County of Fairfax, Virginia

STAFF REPORT

APPLICATION RZ/FDP 2010-LE-013

PROPOSAL: Request to rezone 1.63 acres from the C-6 District to the PDC District to establish a 120,000 SF extended stay hotel.

BULK PLANE DIAGRAMS

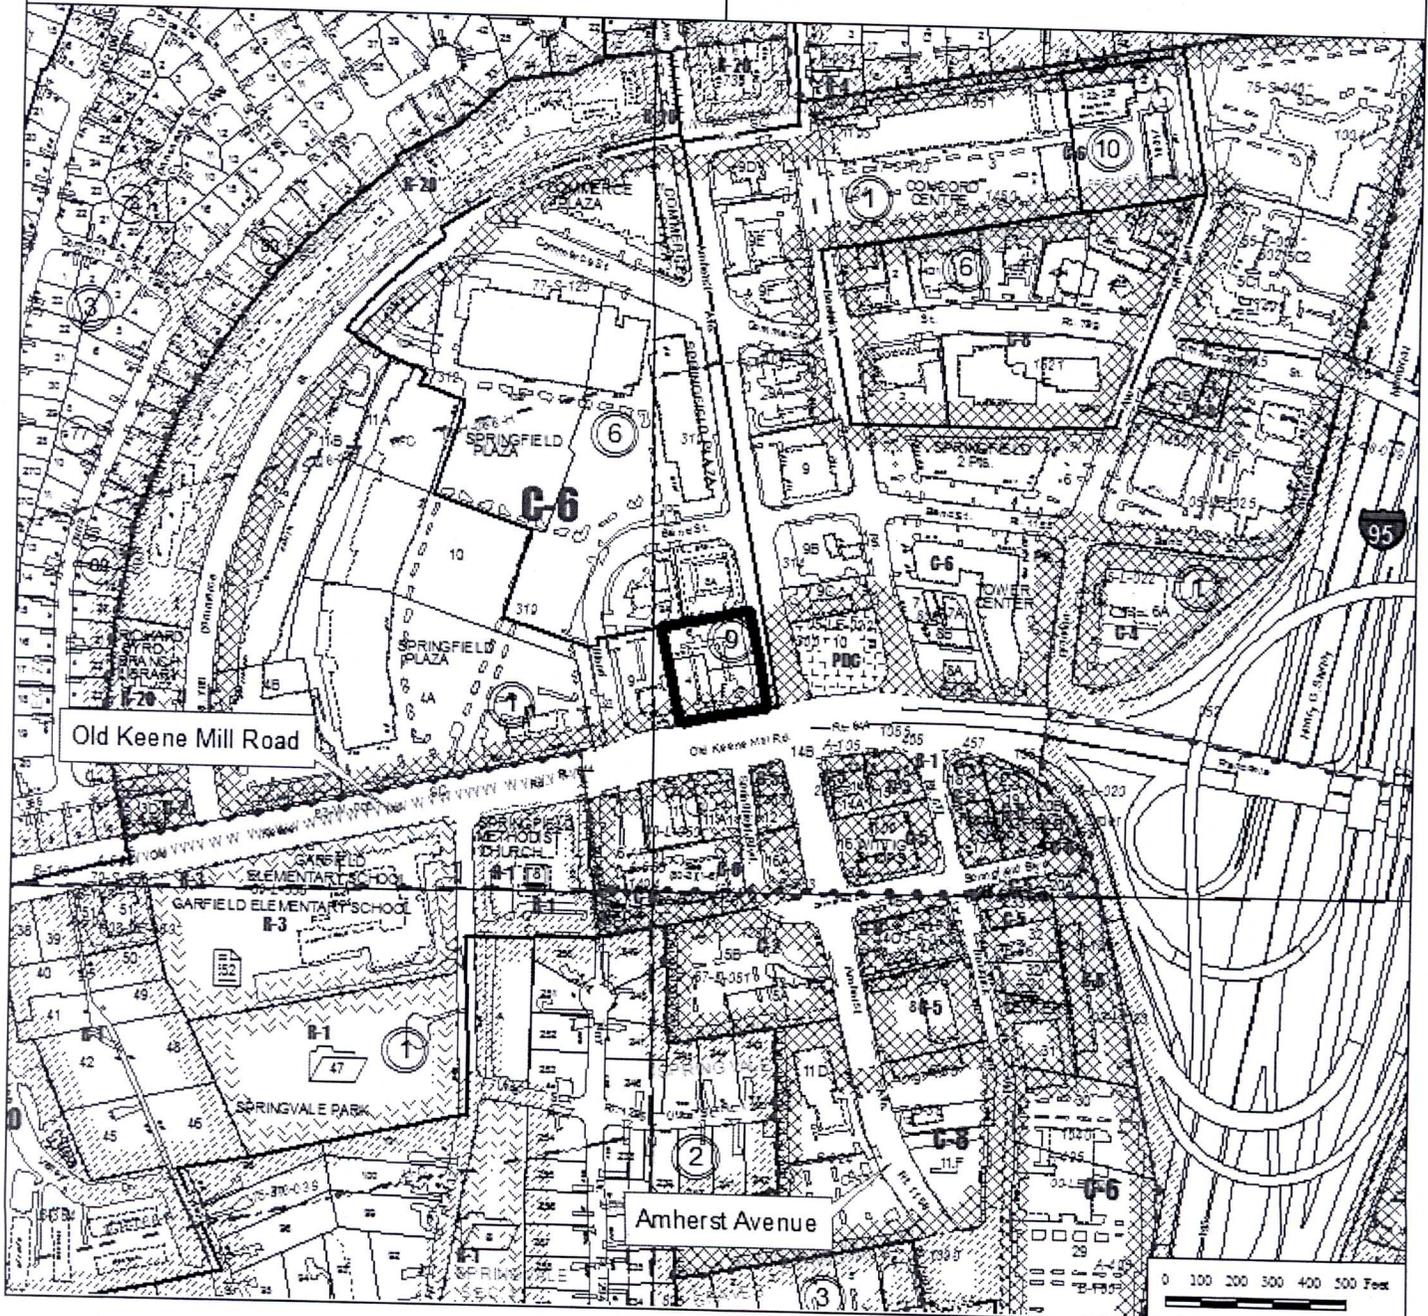
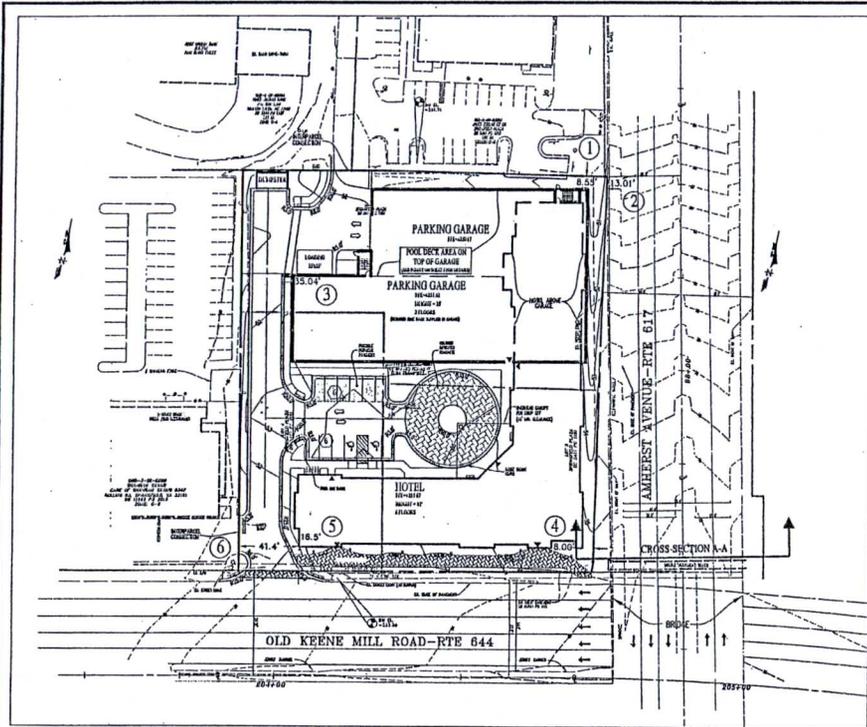
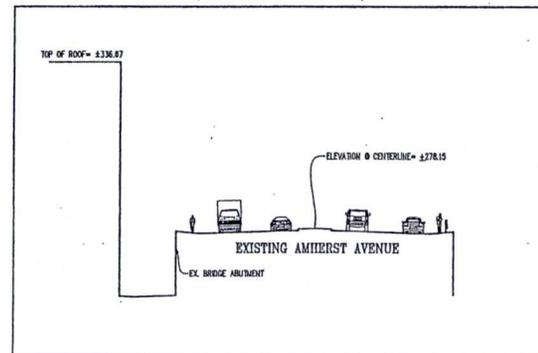
Modification of the front yard 45-degree bulk plane requirements to permit a front yard bulk plane of 4 degrees.

The proposed hotel building is oriented towards the Amherst Avenue and Old Keene Mill Road frontages of the site as recommended by the Comprehensive Plan. In addition, the building is oriented around the proposed parking garage to screen it view from Amherst Avenue and Old Keene Mill Road, also as recommended by the Comprehensive Plan. As a result, the minimum bulk plane along the Amherst Avenue frontage of the site is 4 degrees. Modifications of the minimum yard requirements are permitted in Commercial Revitalization Districts when the approval of such modification would further the goal of revitalization and the Comprehensive Plan recommendations for the site. Staff believes that the proposed layout is in harmony with the Comprehensive Plan recommendations for the site and therefore, staff supports this modification request.

LANDSCAPE PLAN
SPRINGFIELD HOTEL
 CDP/FDP
 LEE DISTRICT
 FAIRFAX COUNTY, VA
 CL: Z
 DATE: JULY 2010
 SCALE: 1"=30'

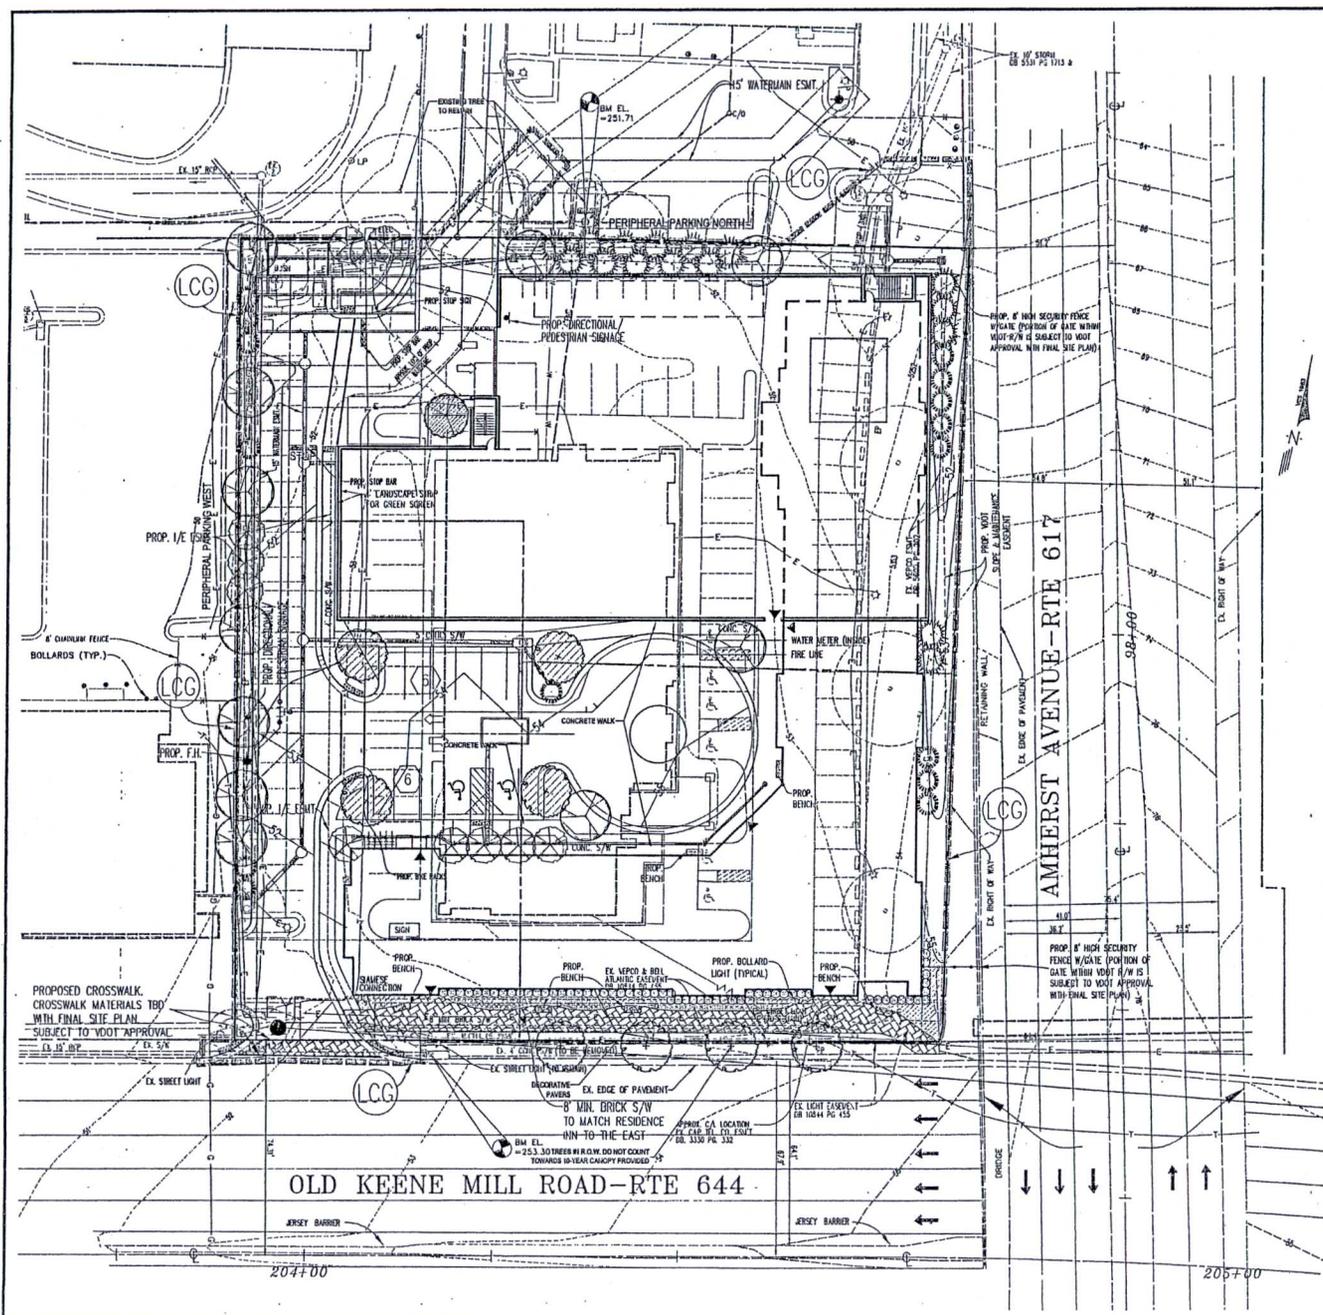
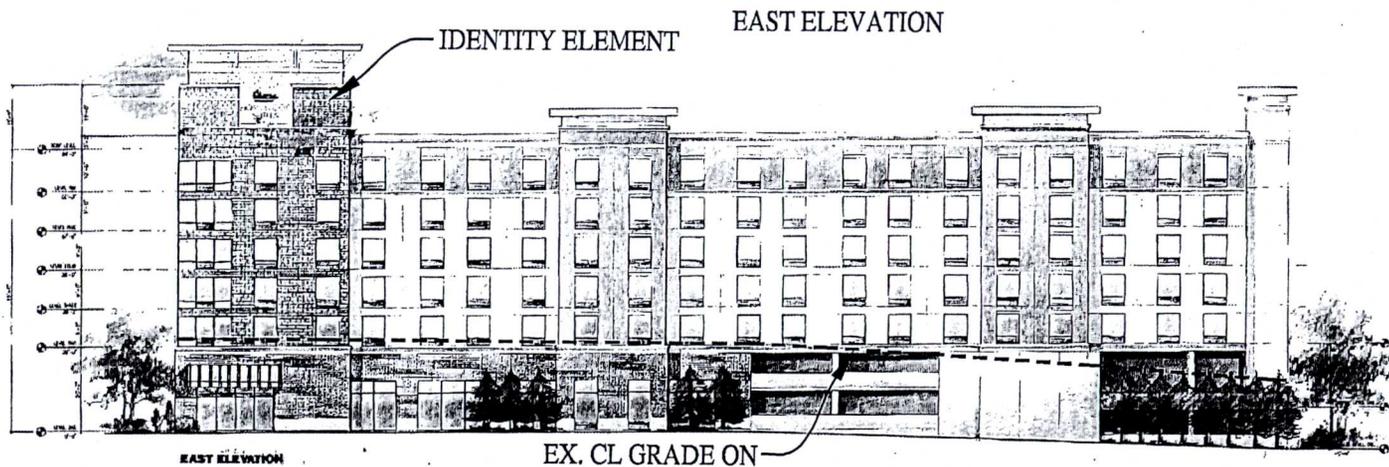
UFMD staff noted that a deviation from the tree preservation target was requested by the applicant, but the deviation request did not include one or more of the justifications listed in the Public Facilities Manual (PFM), and therefore the deviation request did not appear to be in conformance with Chapter 122-2-3(b) of the County Code. UFMD staff recommended that the applicant provide one or more of the justifications listed in the PFM on the CDP/FDP, with a narrative that provides a site-specific explanation of why the Tree Preservation Target cannot be met.

Urban Forest Management staff noted the CDP/FDP depicted proposed landscaping along the northern and western portions of the property, which appeared to be located inside an existing VEPCO easement and it was unclear if permission from VEPCO to plant inside their easement had been obtained. UFMD recommended that the mentioned trees should be relocated outside of the existing VEPCO easement, or a letter of permission from VEPCO should be provided on the CDP/FDP to allow the planting of trees inside the existing VEPCO easement. UFMD staff further noted that trees located inside public utility easements, even with a letter of permission, cannot be counted for tree canopy credit and if that was the case, the 10-year tree canopy calculations should be adjusted accordingly.

The applicant has revised the CDP/FDP to provide a narrative of Sheet 13, which states that:

The justifications provided by the applicant are conditions under which a deviation from the tree preservation target is allowed (PFM Sect. 12-0507.3). Furthermore, the CDP/FDP notes that the overall 10-year tree canopy cover required for the site (10%) will be provided with the new proposed plantings shown on the Landscape plan. Based on the provisions discussed, staff is not opposed to the Director of DPWES granting a deviation from the tree preservation target for the proposed development.

The applicant has revised the CDP/FDP to relocate the proposed plantings, so they are not located within the existing VEPCO easement. Therefore, this issue has been resolved.

POOL DECK

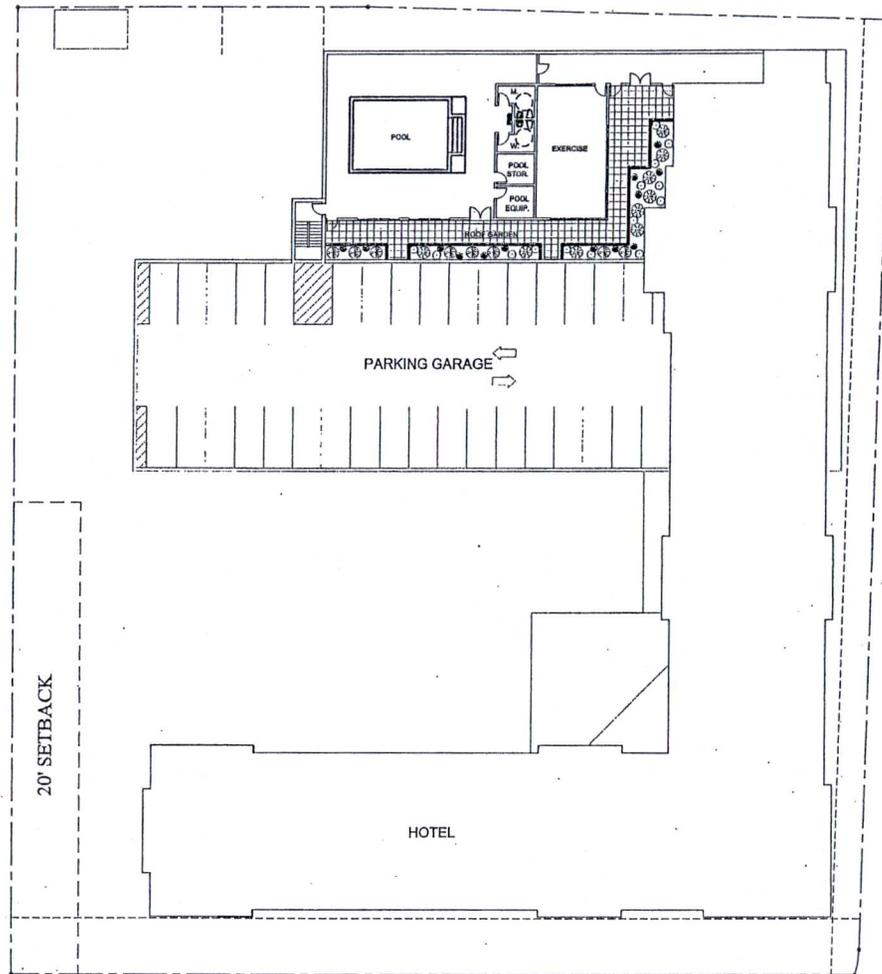
- a vegetated roof on the hotel with access for the guests to enjoy,
- a roof deck on the garage as an outdoor amenity and for harvesting of rainfall for water supply needs (for water features, irrigation),
- amended soils with native plantings, including grasses and wildflowers, where appropriate,
- porous concrete paving or permeable pavement blocks with underlying gravel storage in the parking areas.

UFMD staff noted that the Comprehensive Plan guidance for the application property specifically mentions the need to address the demand for urban parks and recreational facilities when seeking to develop under the option for hotel use on Parcels 4, 5 and 6. FCPA staff recommended that the site design be revised to integrate usable, public open space into the design, consistent with the Fairfax County Urban Parks Framework, to address the guidance of the Comprehensive Plan. The applicant had proposed to address the Comprehensive Plan language through a draft proffer, committing to escrow \$10,000 to be used for public recreation facilities in the planned commuter parking facility on the south side of Old Keene Mill Road. The draft proffer additionally states that funds not used within five years could be utilized for improvements to parks located within the vicinity of the application.

The CDP/FDP has been revised to include a pool deck illustrative and a pool deck layout, which depicts an area on the roof of the proposed parking structure to consist of a pool, exercise facility and a roof garden. The applicant has also proffered to provide a rainwater collector system on the site, and the collected stormwater will be used to supplement irrigation of landscaping installed on the site. In addition, the CDP/FDP shows that pervious pavement may be provided over a portion of the proposed surface parking area near the courtyard entrance to the building. Based on the provisions discussed, staff believes that this issue has been resolved.

The applicant has revised the CDP/FDP to provide a "Pool Deck Layout" to depict the proposed pool, roof garden, and exercise facility to be provided above the parking garage; however, those facilities will be available to hotel guests. In addition, the applicant has proposed a proffer to contribute the sum of thirty-two thousand four hundred dollars (\$32,400.00) to the Fairfax County Park Authority at time of site plan approval for the hotel, to be used for the integration of public recreation facilities into

PEDESTRIAN CIRCULATION PLAN
SPRINGFIELD HOTEL
 CDP/EDP
 11th DISTRICT
 FAIRFAX COUNTY, VA

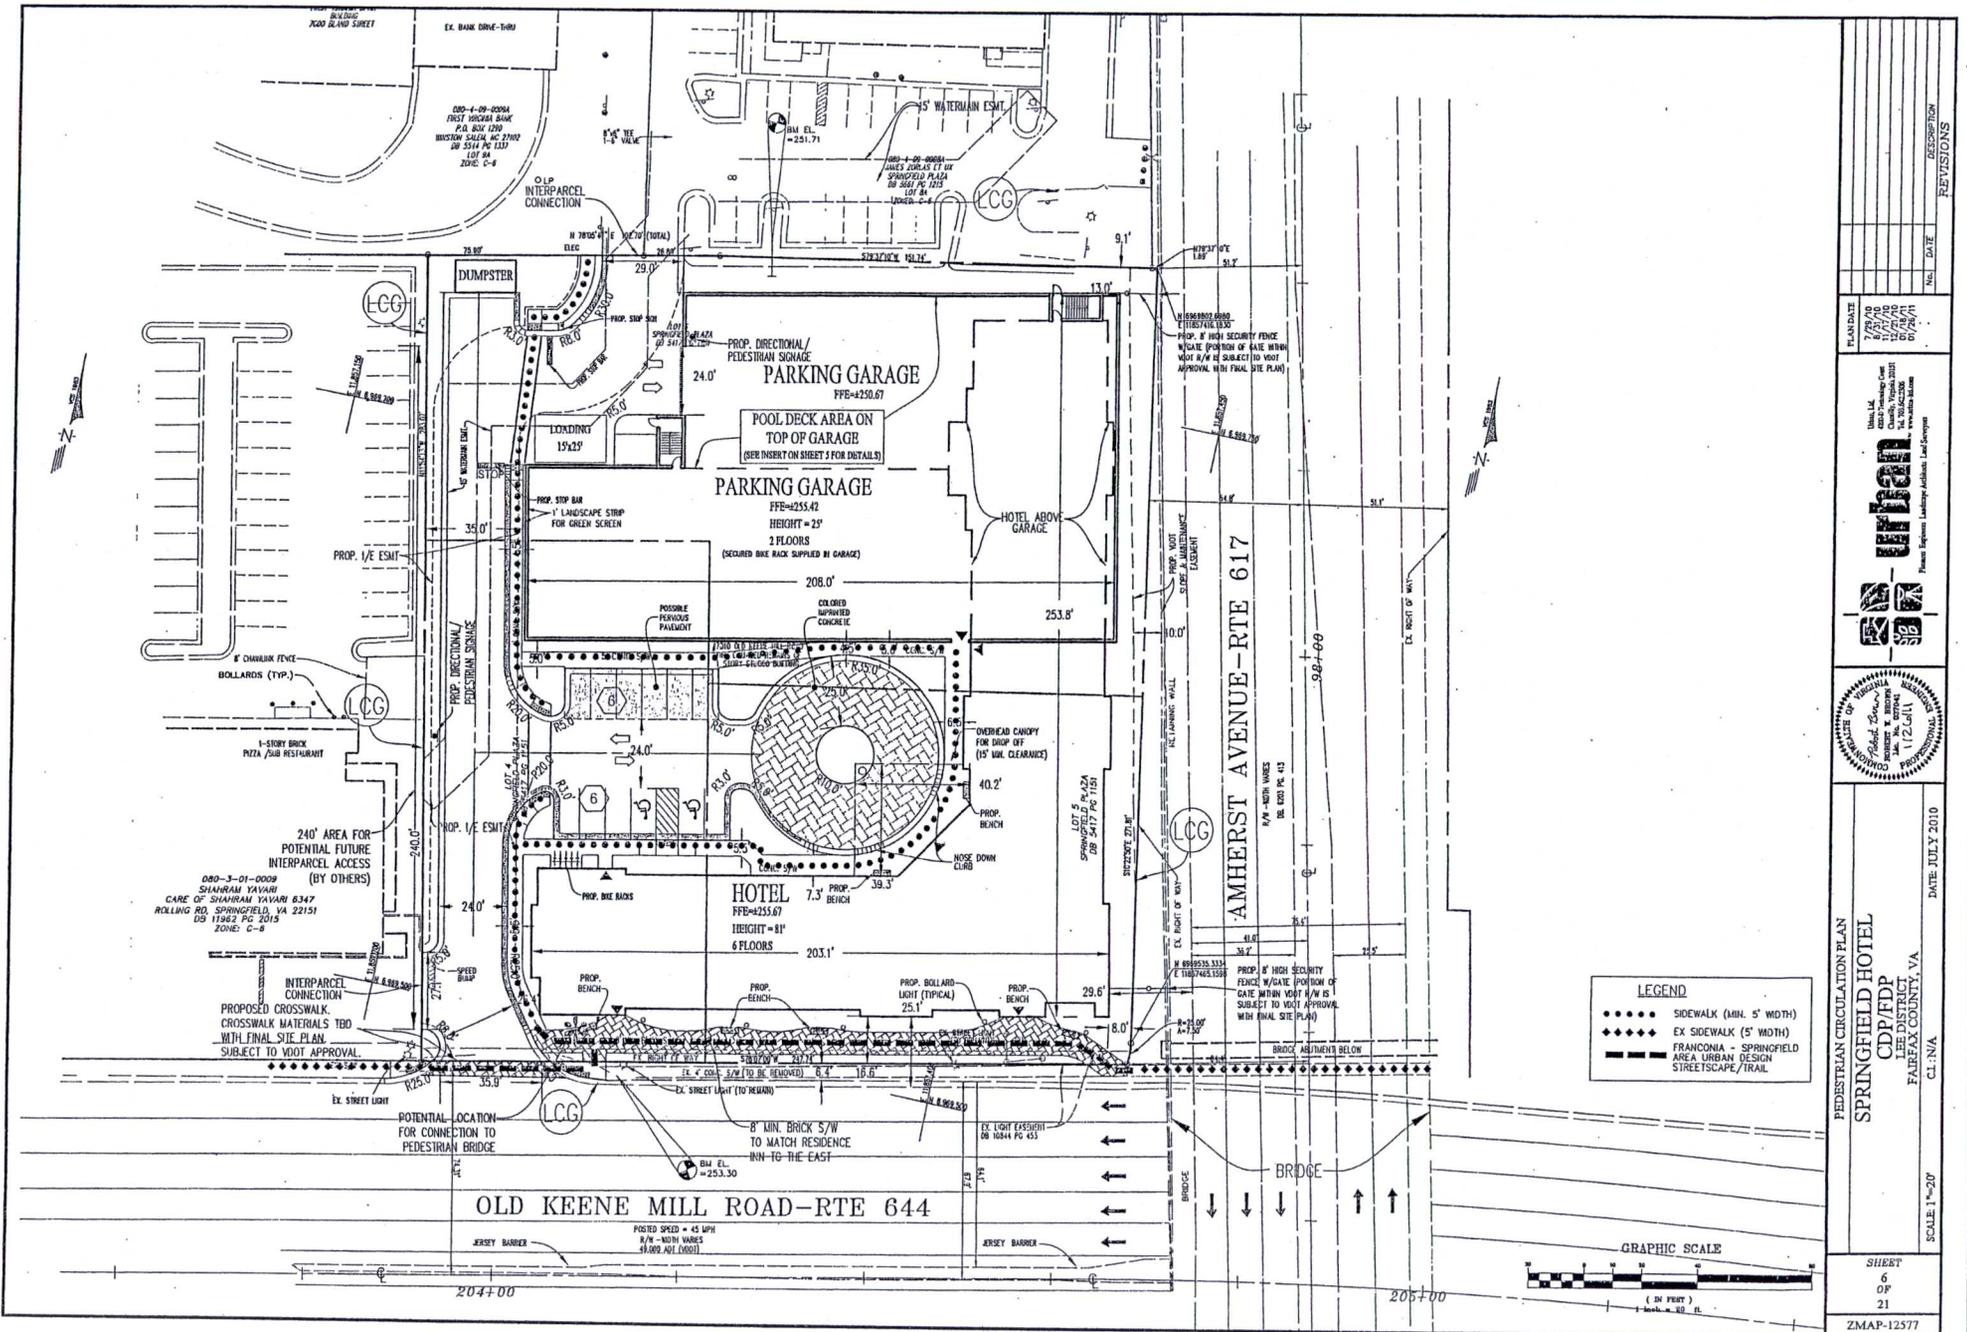
Staff previously requested that the applicant provide additional information about vehicular circulation at the northern portion of the site including within the parking structure. Staff was concerned that the location of the parking garage entrance would lead to potential pedestrian-vehicular conflicts. More information about how the loading area would work was also requested.

The applicant revised the CDP/FDP to include a pedestrian circulation plan that delineates the pedestrian paths throughout the proposed development including the northern portion of the site near the entrance to the proposed parking structure. The pedestrian plan also identifies the locations for proposed stop signs and stop bars in order to prevent pedestrian-vehicle conflicts within the development. The CDP/FDP has also been revised to include a parking garage layout in order for staff to evaluate the feasibility of relocating the entrance/exit to the garage. Based on the provisions discussed, staff believes that the applicant has provided measures that will prevent pedestrian-vehicular conflicts and provide for safe pedestrian and vehicular circulation within the proposed development. Therefore, this issue has been resolved.
